RAI Volume 2, Chapter 2.1.1.1, Second Set, Number 1: Provide a geological map covering the footprints and geological cross sections (in the east–west and north south directions) of the surface and subsurface portions of the Geological Repository Operations Area (GROA) at a scale sufficient to delineate geologic features such as faults and stratigraphic contacts, and their relationship to major GROA features such as drifts, shafts, ramps and SSCs [structure, system, or component] important to safety and waste isolation (SAR [Safety Analysis Report, part of the License Application] Section 1.1.5.1.2; SAR Section 1.1.5.1.4).

Response Tracking Number: 00070-01-00

RAI: 2.2.1.1.1-2-001

Figure 1. Geologic Map of the Surface Geologic Repository Operations Area with the Locations of Six Geologic Cross Sections, Boreholes, and Planned Important to Safety (ITS) Structures

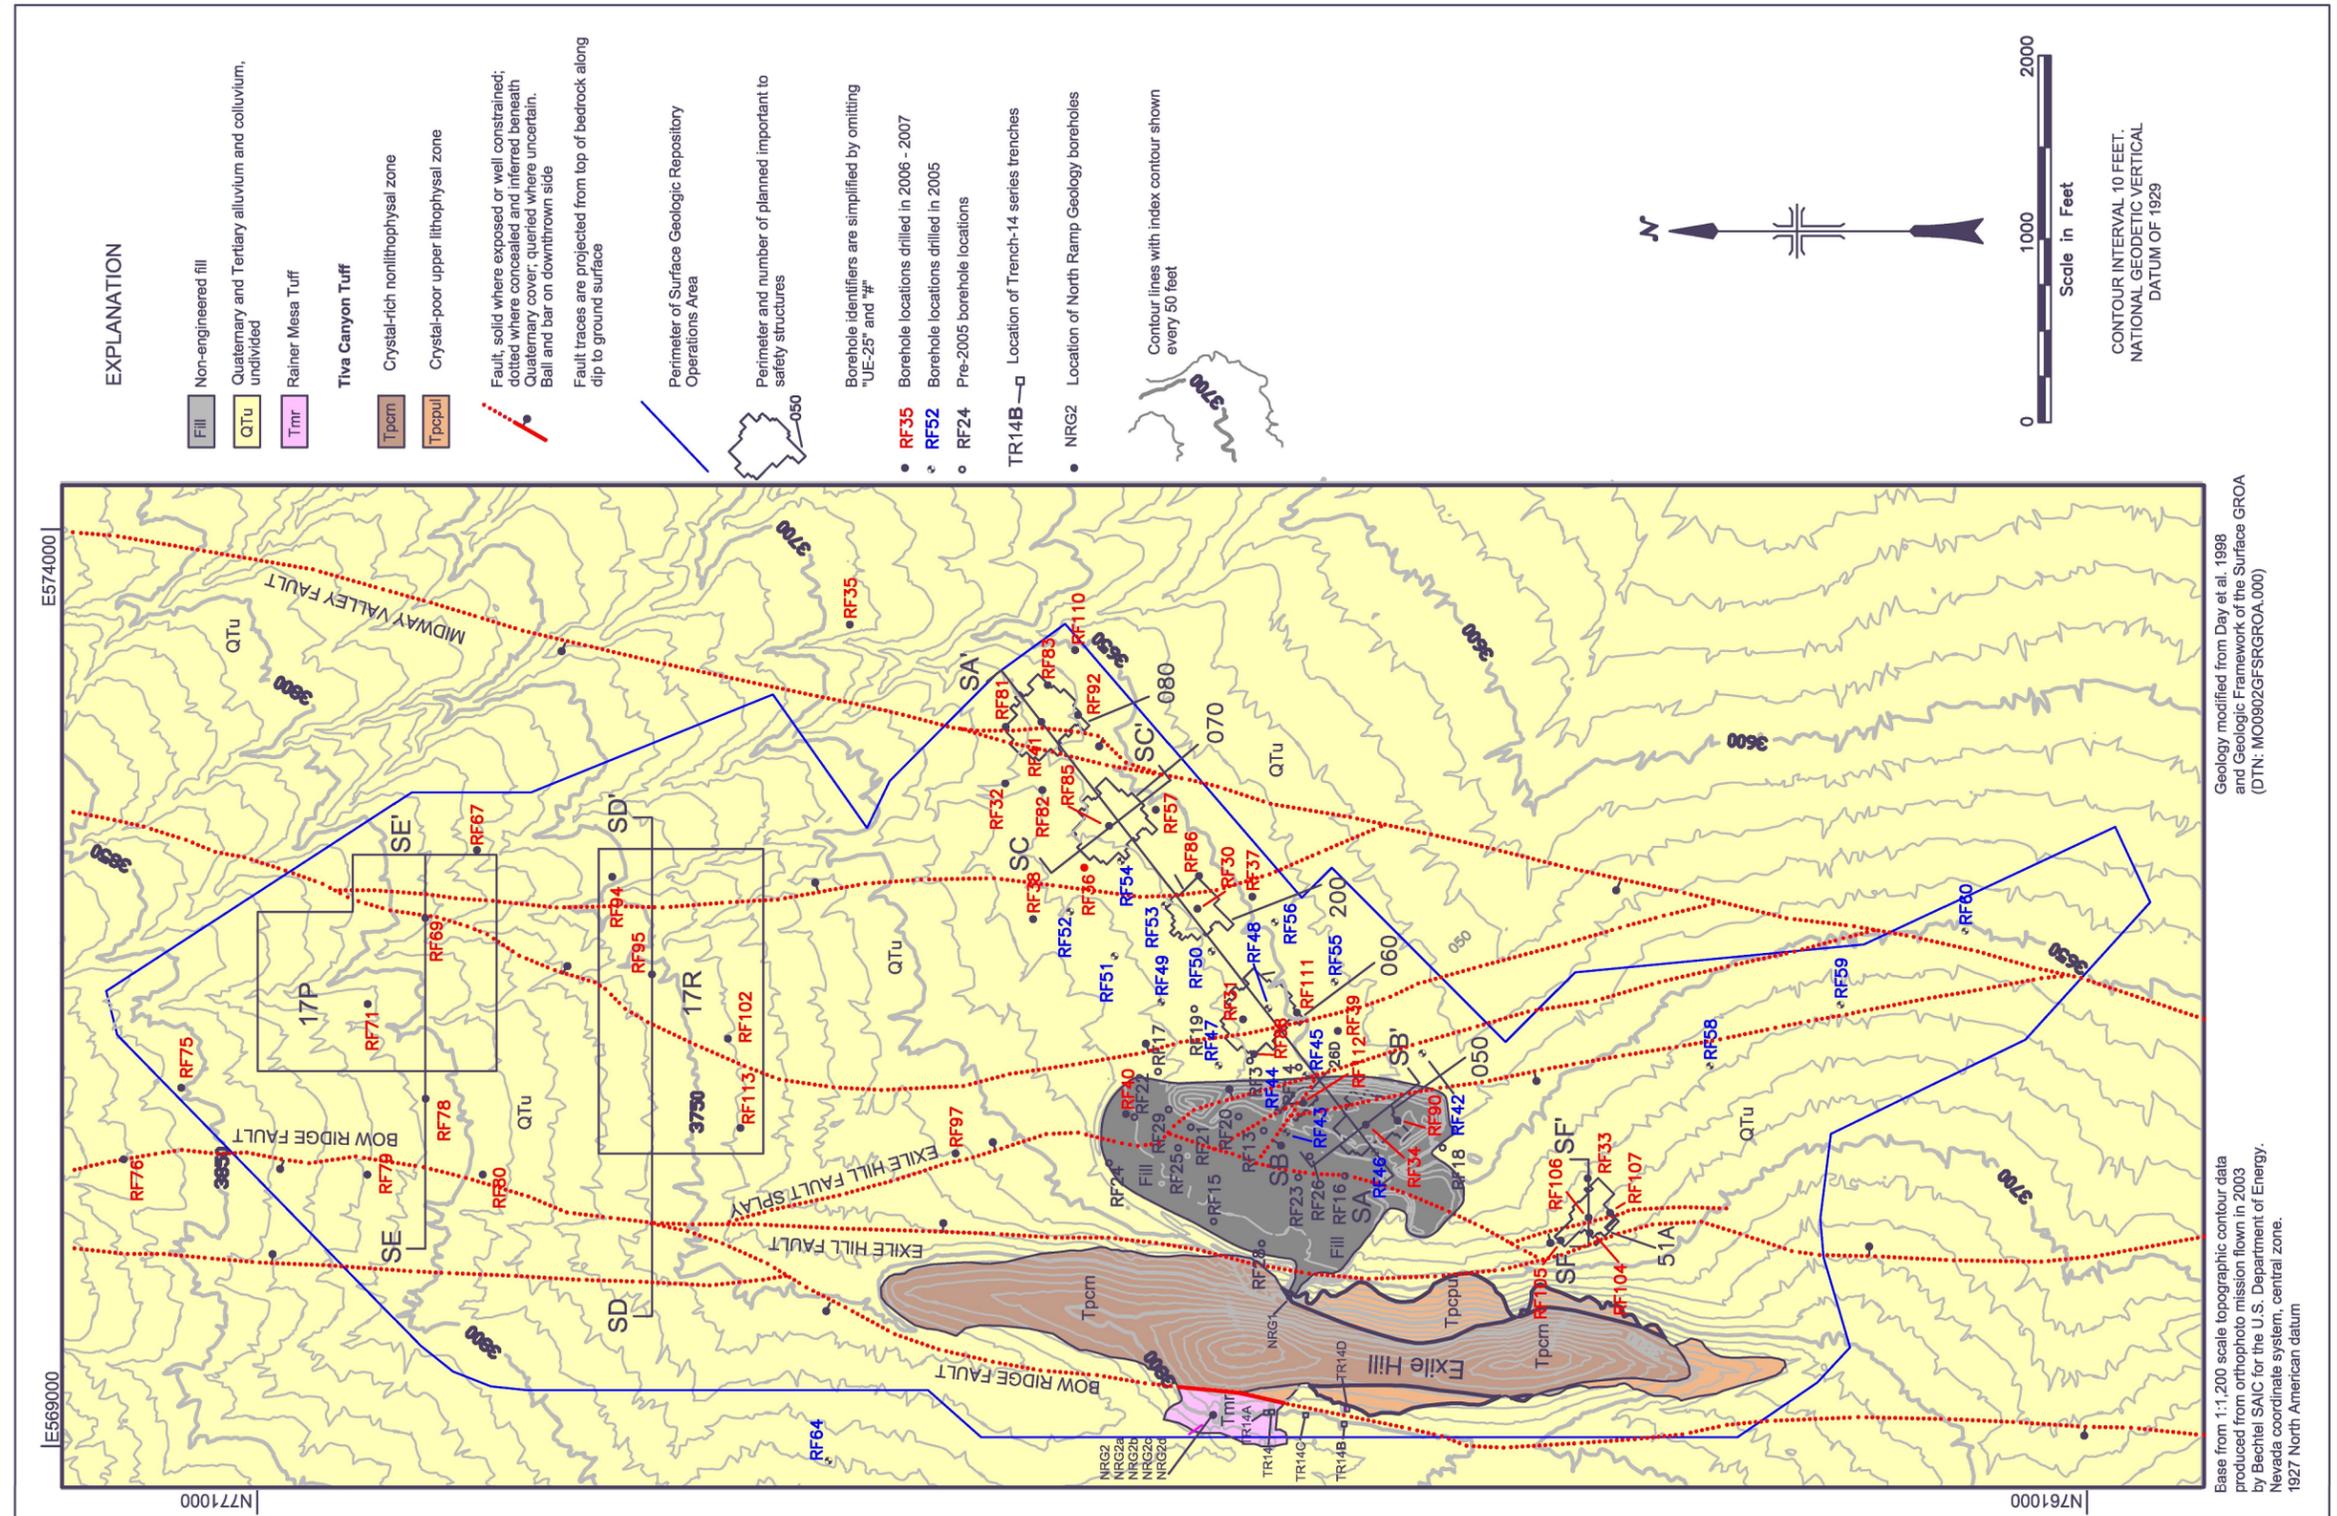
The geological map provided at a scale of approximately 1:15,000 as Figure 1.1-64 in SAR Section 1.1.5.1.4, covers only the central and western portion(s) of the surface GROA footprint and DOE does not provide a detailed geological map of the subsurface GROA footprint. The geological cross sections shown in Figures 1.1-65 to 1.1-67 cover only a portion of the surface GROA footprint. SAR Section 1.1 does not provide any detailed geological cross sections intersecting the width and length of the subsurface GROA footprint. This information is needed to support the preclosure safety analysis and the GROA design and establish compliance with 10 CFR 63.21(c) (1) (ii) and 10 CFR 63.112(c).

Five lithostratigraphic units are exposed at the surface on the geologic map of the surface GROA (Figure 1; Day et al. 1998). Quaternary to Tertiary undivided alluvium-colluvium (QTu) is exposed across most of the map area. The nonengineered pad fill and muck pile (Fill) is east of Exile Hill. The Miocene Rainier Mesa Tuff (Tmr) is exposed in a small area on the west side of Exile Hill. Two units from the Miocene Tiva Canyon Tuff (Tpc), the crystal-rich (r) nonlithophysal (n) zone (Tpcrn) and the crystal-poor (p) upper lithophysal (ul) zone (Tpcpul), are exposed on Exile Hill.

Faults included on the surface GROA map are based on various types of information; however, almost all faults are concealed under the alluvium-colluvium and have no surface expression. The only fault with established Quaternary activity is the Bow Ridge fault, documented in the Trench-14-series trenches on the west side of Exile Hill (Keefer et al. 2004, Table 1 and p. 59-

Several of the faults within the surface GROA map (Figure 1) are based on or modified from inferred faults depicted on the geologic map of Day et al. (1998) and within the Geologic Framework Model 2000 (GFM2000; BSC 2004). The “Exile Hill fault splay” was identified in the drilling in 2000 (BSC 2002), and the location and geometry of the fault were refined on the basis of drilling in 2007 with penetration of the fault in boreholes UE-25 RF#40 and UE-25 RF#97. Most of the concealed faults are inferred between boreholes to reconcile changes in thickness of lithostratigraphic units (Buesch and Lung 2008), and in the GFSG they are based on construction of a reference structure contour map on top of the crystal-rich, nonlithophysal zone of the Tiva Canyon Tuff (Tpcrn). Several other RF-series boreholes penetrate faults that are consistent with the inferred position of faults, and therefore, these penetrations were used to geometrically constrain the faults. The following three guidelines were used in constructing all the concealed faults in the surface GROA:
